4 LOT SUBDIVISION

Day Street
Brooklyn, Connecticut

ENGINEERING PLAN REVIEW PERTAINING TO A 4-LOT SUBDIVISION CNG HOLDINGS, LLC (ASSESSOR'S MAP 42, LOT No. 32) DAY STREET BROOKLYN, CT (May 7, 2021)

Existing Condition Plan

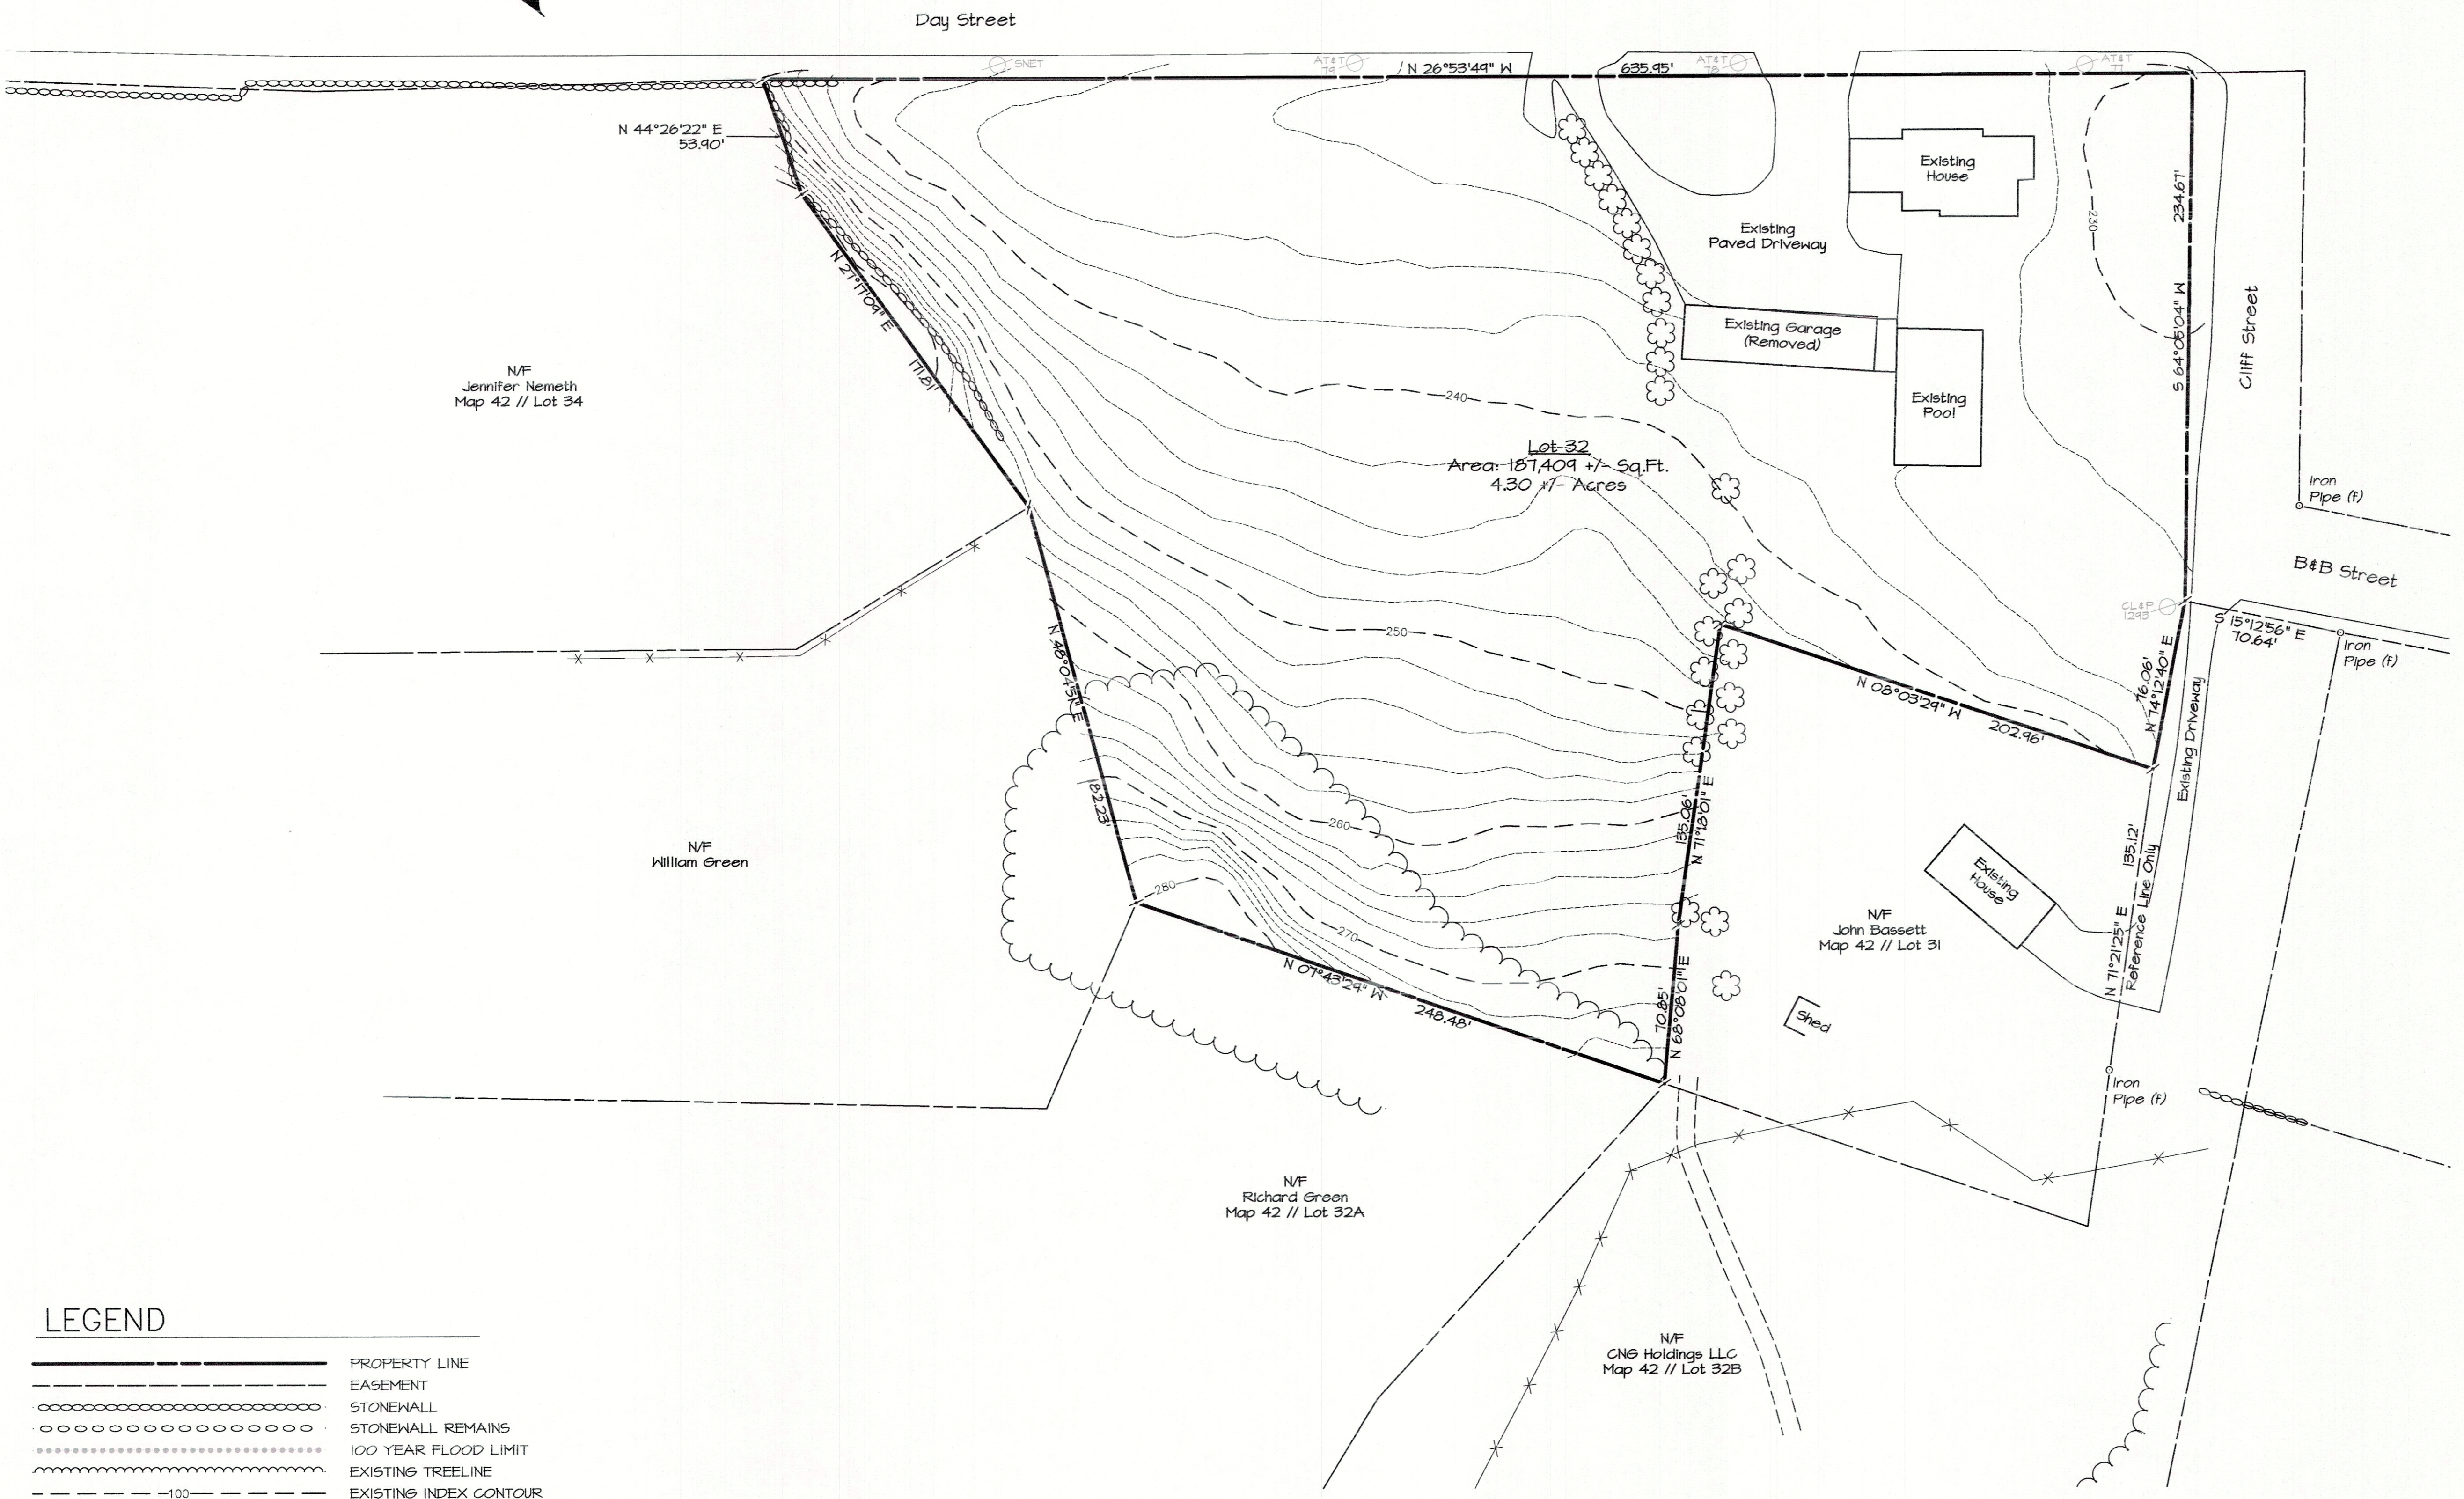
Sheet 2 of 7 – Existing Condition Plan

1. Location Map is missing a north arrow.
2. Note 1 under “Notes” does not include the accuracy of the topographic elevations shown on the plan. The accuracy needs to be included as part of this note.
3. A silt fence, compost/silt sock and/or hay bale sediment control symbol needs to be included in the “Legend.”

Subdivision Plan
"4 Lot Subdivision"
Prepared For:
CNG Holdings LLC
Day Street
Brooklyn, Connecticut

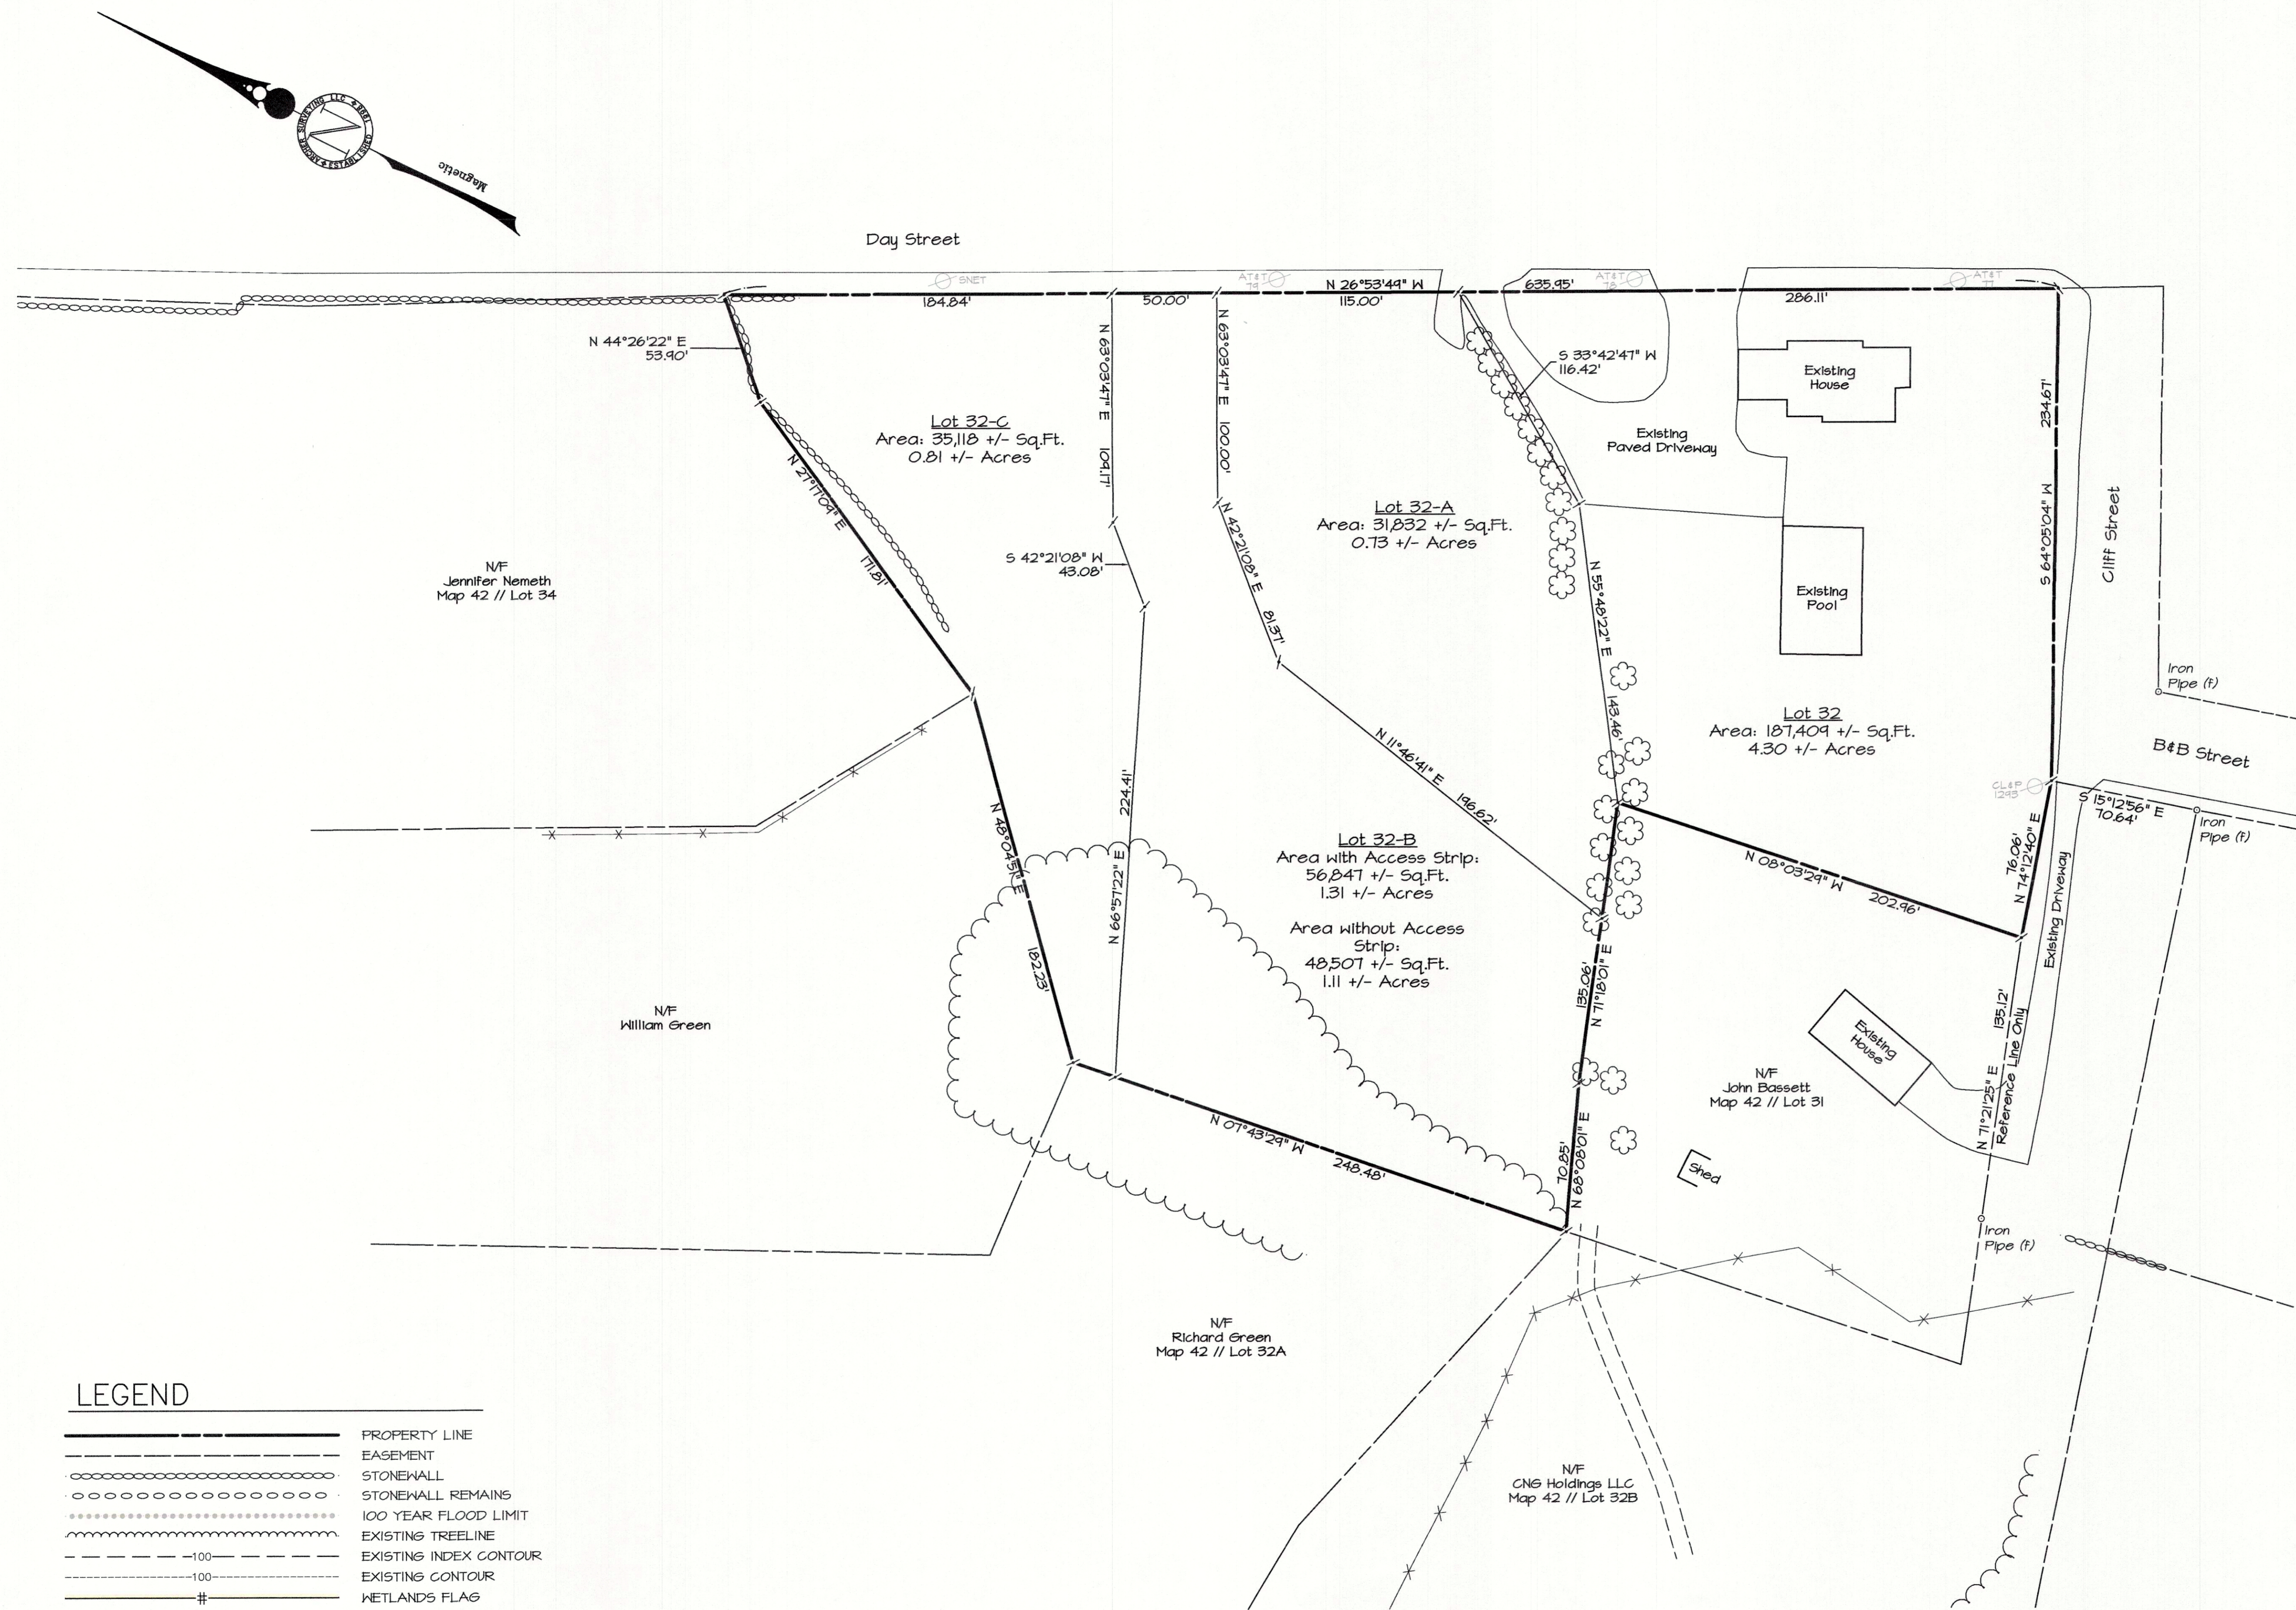
Sheet 3 of 7 – Subdivision Plan

1. Zoning criteria is missing on this plan.
2. Note 1 under “Notes” does not include the accuracy of the topographic elevations shown on the plan. The accuracy needs to be included as part of this note.
